Re: *The Woods at Viewcrest* · August 7, 2023 Request for Information (RFI)

Re: Public Comment letter from *Protect Mud Bay Cliffs*
- The Woods at Viewcrest subdivision proposal
- Applicant's 12/5/23 response to the 8/7/23 Request for Information (RFI)
- Is the Woods at Viewcrest Wetland Delineation Fundamentally Flawed?

Re: ***The Woods at Viewcrest*** subdivision proposal
Applicant's 12/5/23 response to the 8/7/23 Request for Information (RFI)
➤ ***Is the Woods at Viewcrest Wetland Delineation Fundamentally Flawed?***

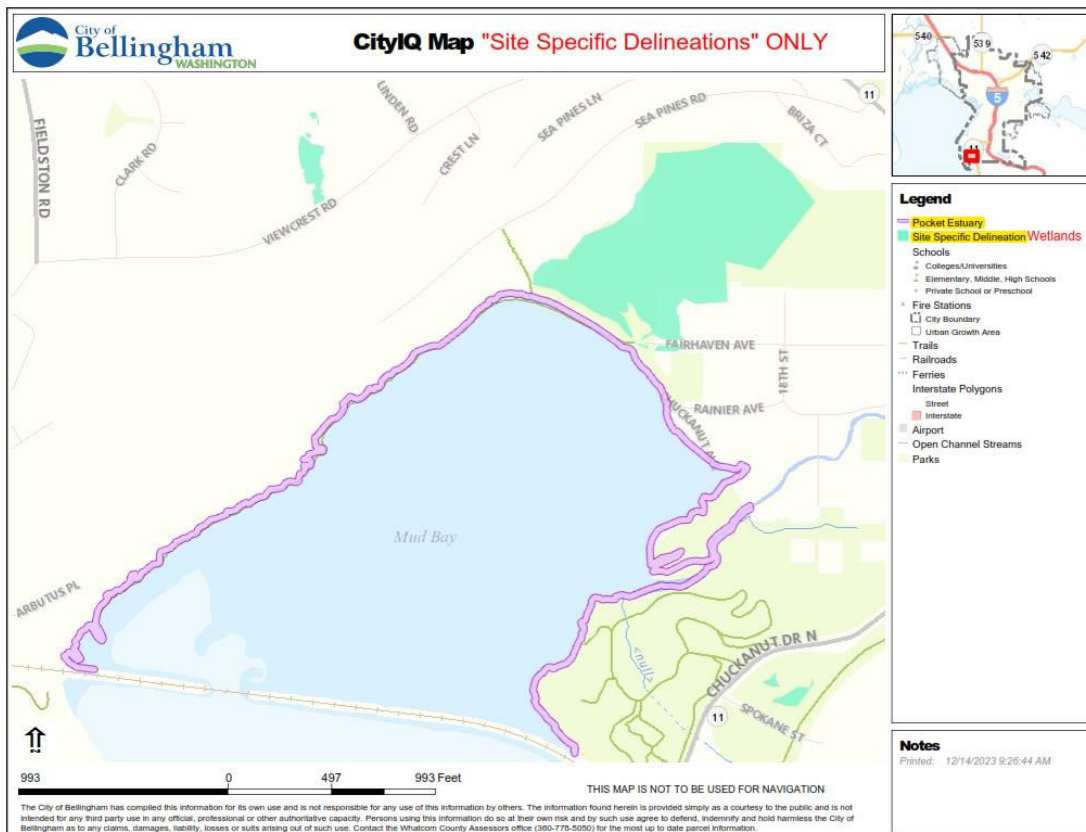
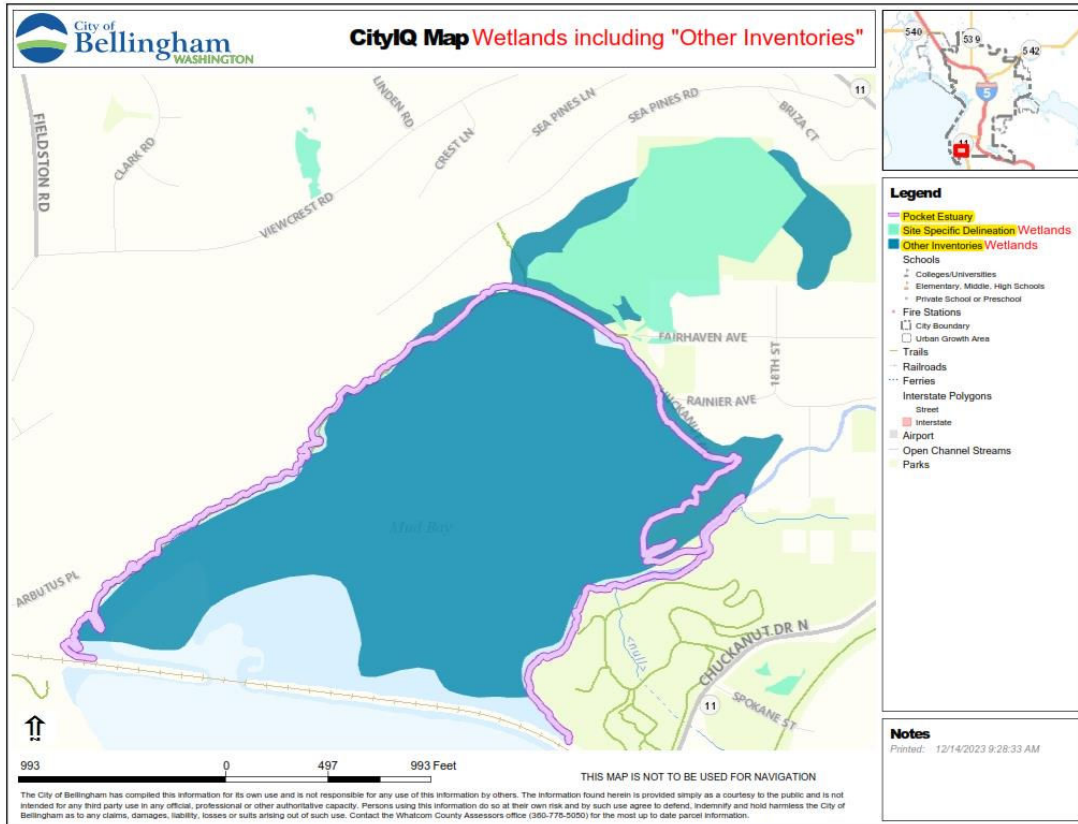
Although the City of Bellingham’s own CityIQ maps show Mud Bay as being distinct from Chuckanut Bay, the delineation refers to Mud Bay as Chuckanut Bay.

The NES wetland delineation recognizes the existence of estuarine wetlands throughout the entirety of Mud Bay (referred to as Chuckanut Bay) as identified by the USFWS NWI mapper. However, the delineation only considers a single “field-verified” estuarine wetland based solely on a CityIQ map, which includes only the *Site Specific Delineation* wetland layer. A more complete CityIQ map, which also includes the *Other Inventories* wetland layer, shows a solid zone of wetlands covering the vast majority of Mud Bay.

There is no indication that the NES wetland delineation attempted to confirm whether Mud Bay’s wetlands that were not “field verified” are, in fact, estuarine wetlands. Nor does the delineation acknowledge that Ecology has placed estuarine wetlands in a separate category because they are not conducive to field verification and, therefore, would not be included on a map of site specific delineated (i.e. “field verified”) wetlands.
